# Errata for FXAS21002C

### 2.1 E1: SPI Multipoint Communication

Figure 1. Typical application circuit with addition of tri-state buffer

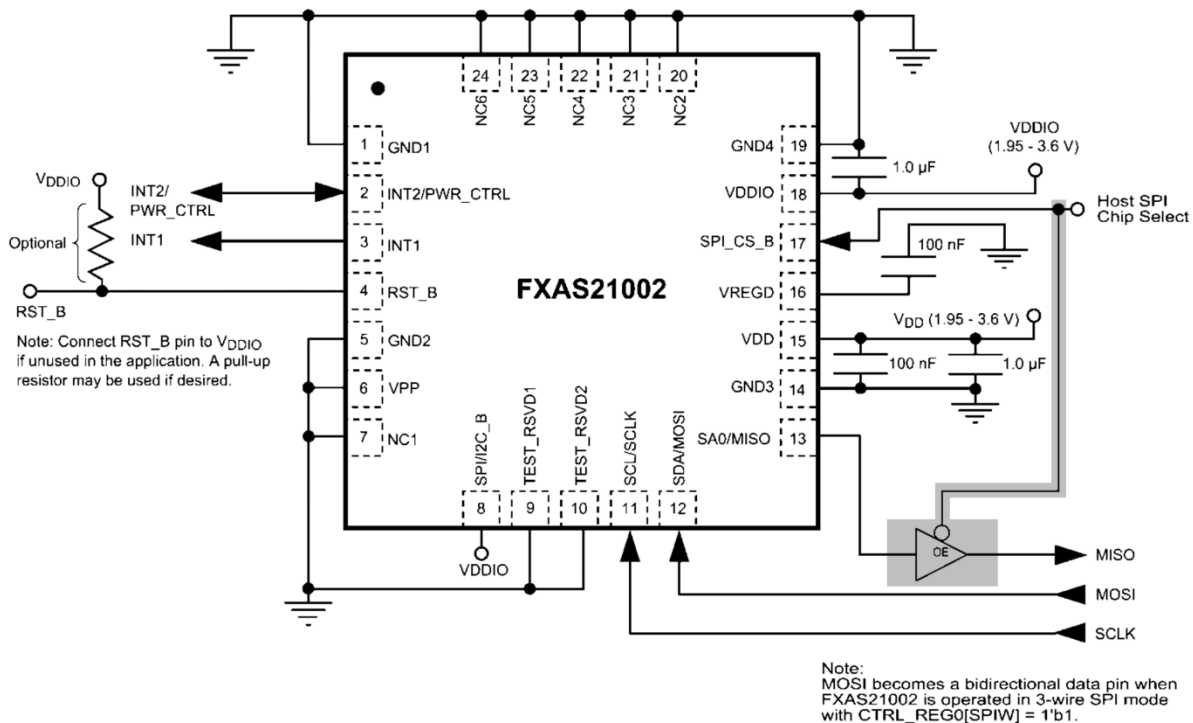
FXAS21002C does not support *multi-point* 4-wire SPI communication protocol (multiple slave devices on the bus).

FXAS21002C, when connected for a 4-wire SPI communication with the master, does not tri-state the MISO line when the SPI\_CS\_B (SPI chip select, Active low) pin is deasserted (logic high). This leads to a bus conflict if there are multiple devices on the same SPI bus. As the part pulls MISO down to GND, instead of tri-stating, this part blocks the other slave devices on the bus from sending data to the master by means of 4-wire SPI communication.

Add a tri-state buffer with the MISO line and the SPI\_CS\_B line as inputs to the buffer (see Figure 1).
